Project	Steamboat Base Village Redevelopment	Date	07/23/2021
Project Location	Steamboat, Colorado	Architect's Project Number	03.7835.000
Owner/Client	Alterra Mountain Company / East West Partners	File	6BL This is page 1 of 2
To	Saunders Construction Inc.	Attention	Bryan Sculthorpe
Address	86 Inverness Place North		
City	Englewood	State	CO Zip Code 80112
Delivered via:	<input type="checkbox"/> Messenger <input type="checkbox"/> Hand carried <input type="checkbox"/> Facsimile <input type="checkbox"/> Express <input type="checkbox"/> Pick-up <input type="checkbox"/> E-mail Address <input type="checkbox"/> Mail <input type="checkbox"/> UPS <input checked="" type="checkbox"/> Website Address BIM360

Bulletin Number - BP3 Promenade - 06

Description of Changes

This bulletin addresses the following:
Landscape planters, site walls, associated grading
Telecom sheet updates for on mountain coordination

1A-C.301

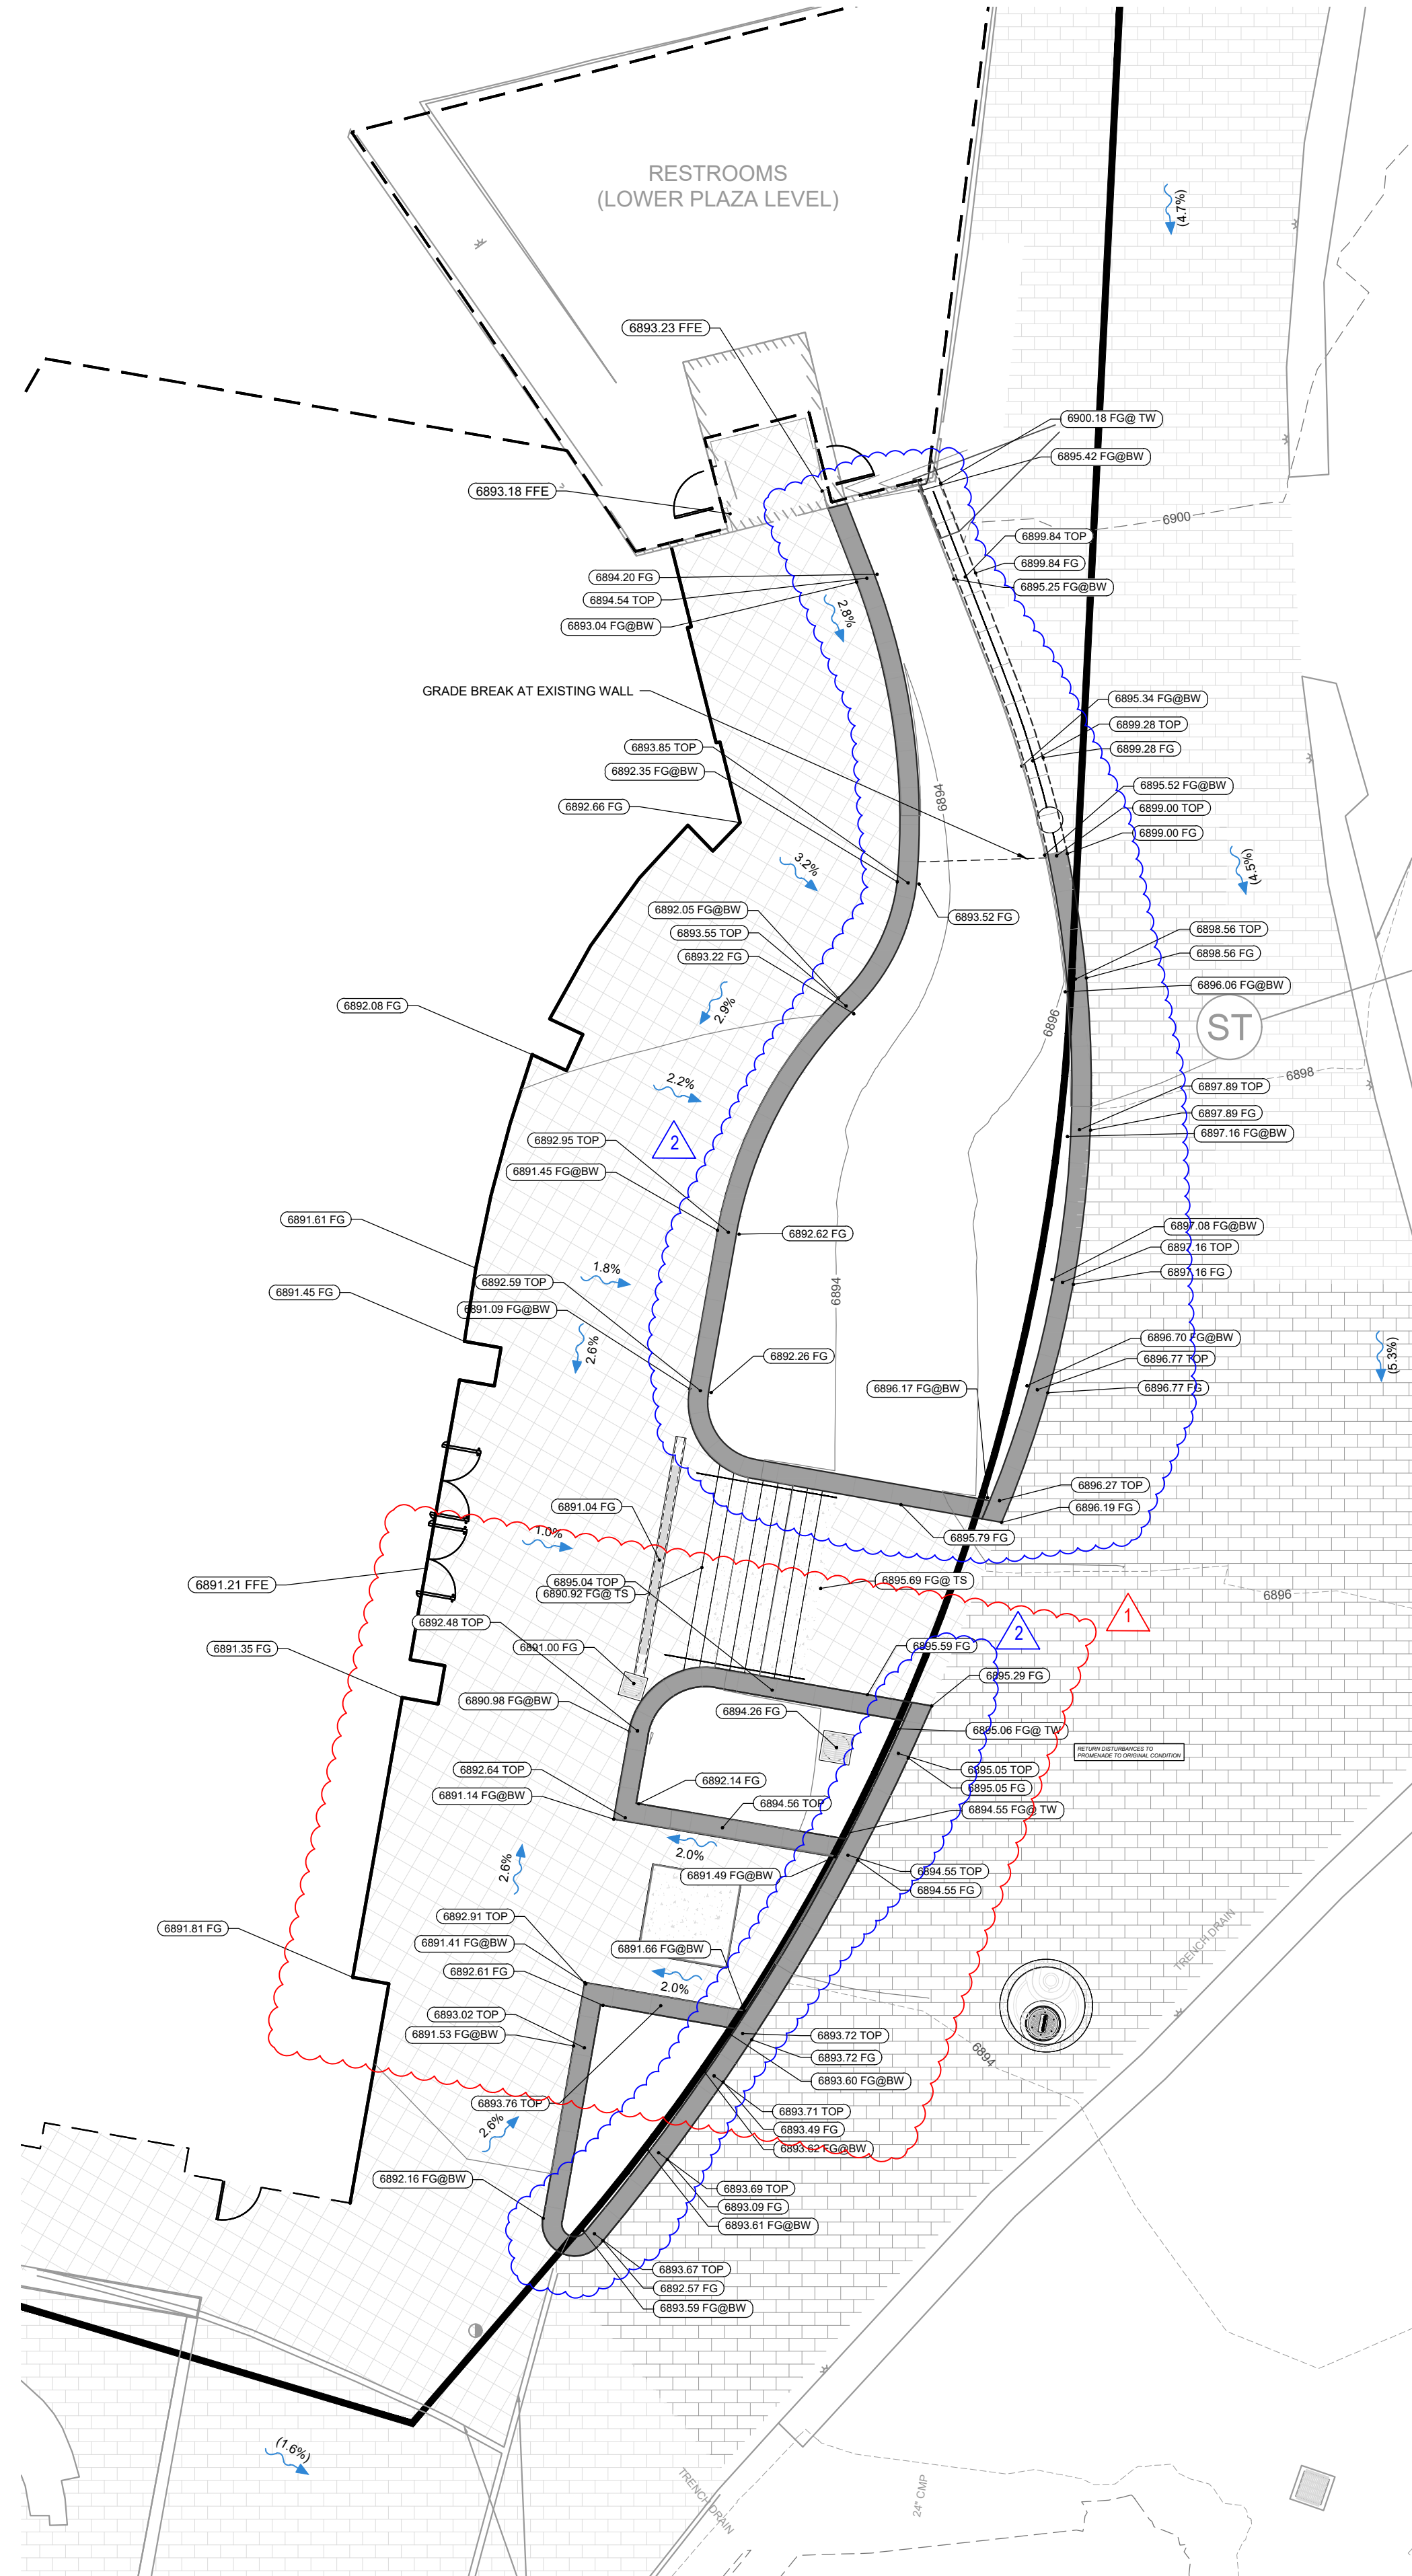
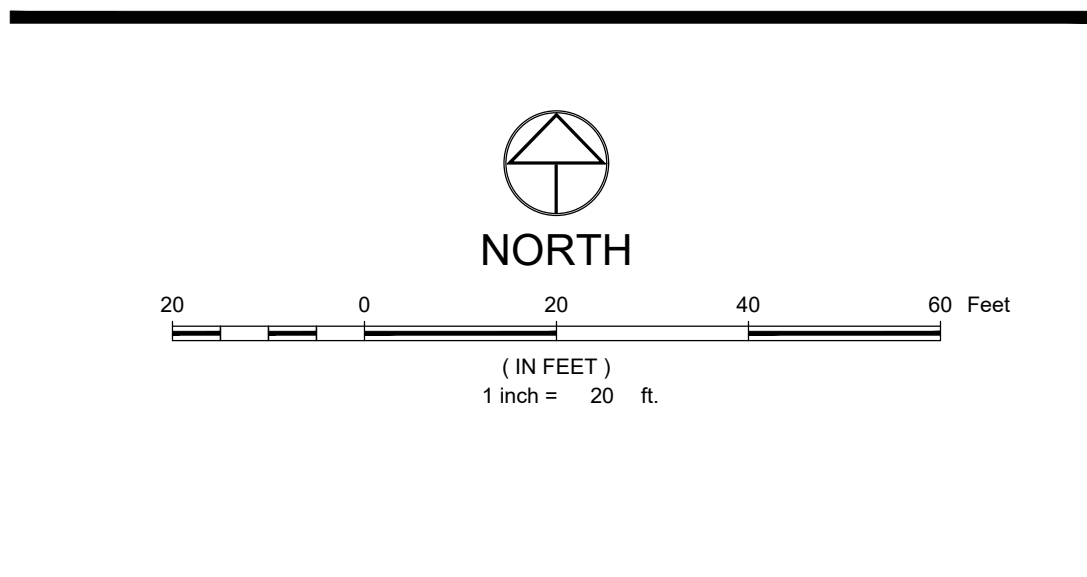
1. 1A-C.301
 - a. Revised grading to the planters and walls along the promenade per design changes by Landscape Architects.

1A-A1.100

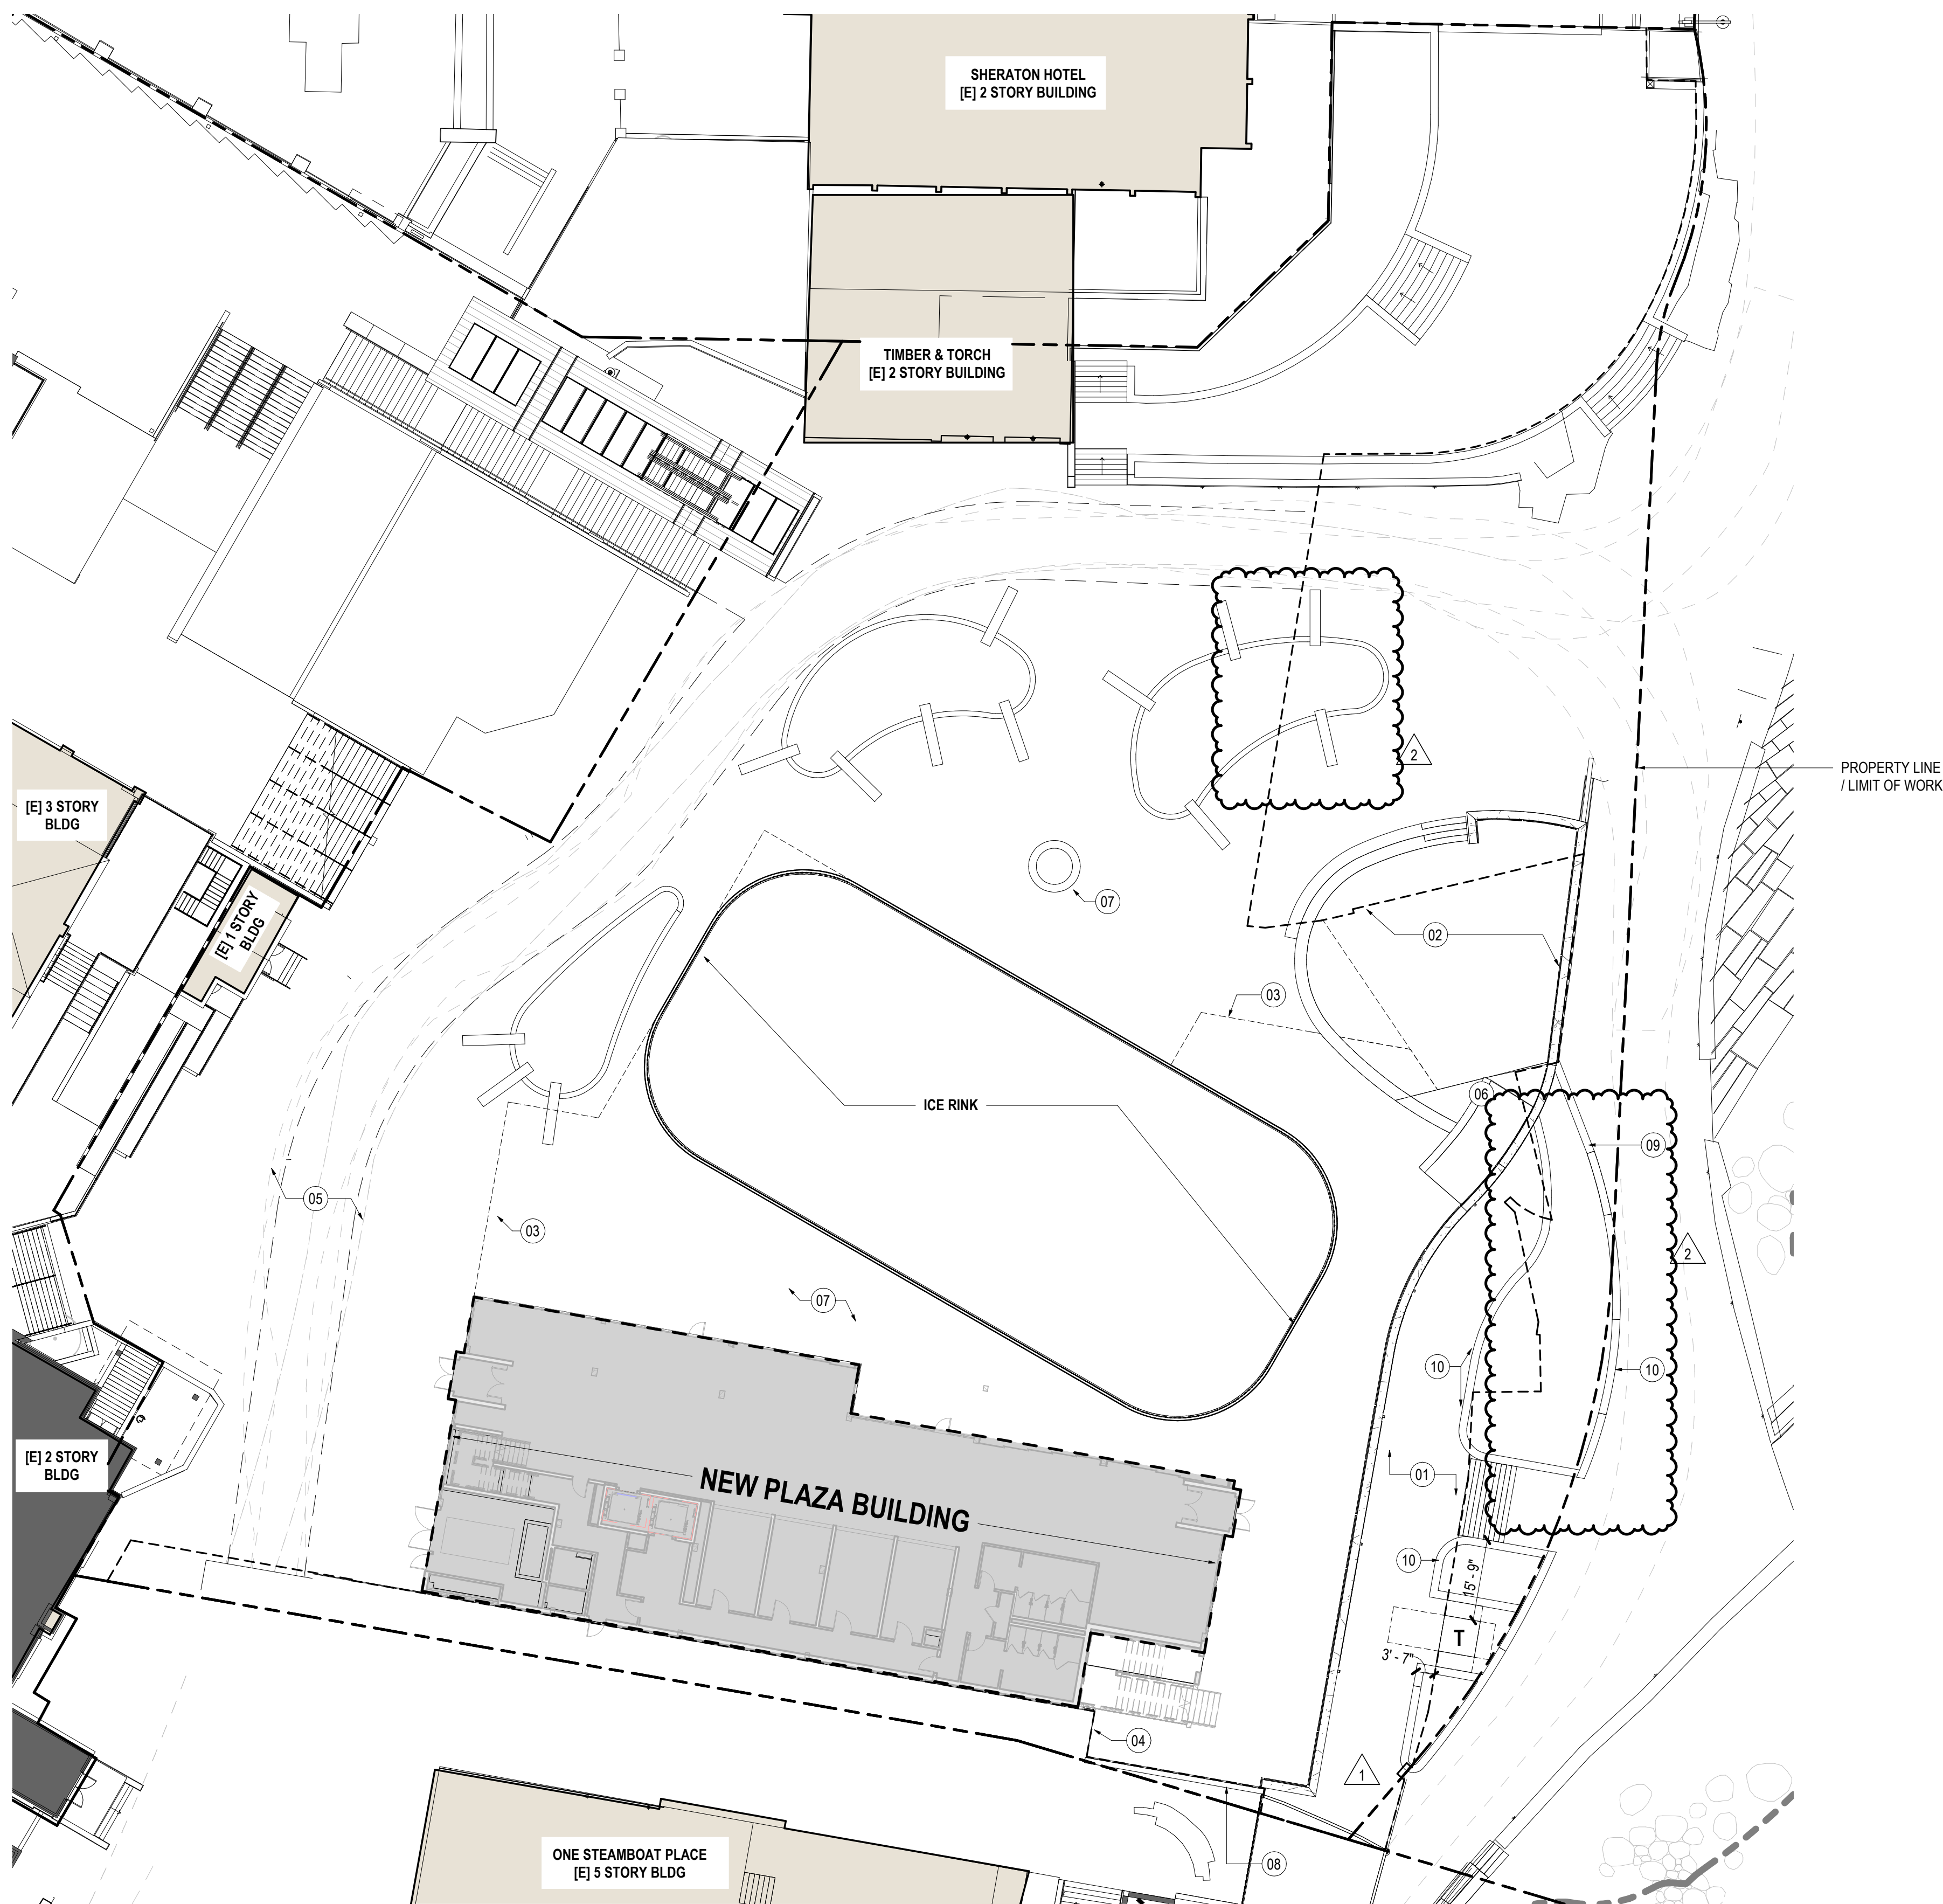
1. 1A-A1.200
 - a. Revised site plan for planters and walls along the promenade per design changes by Landscape Architects.
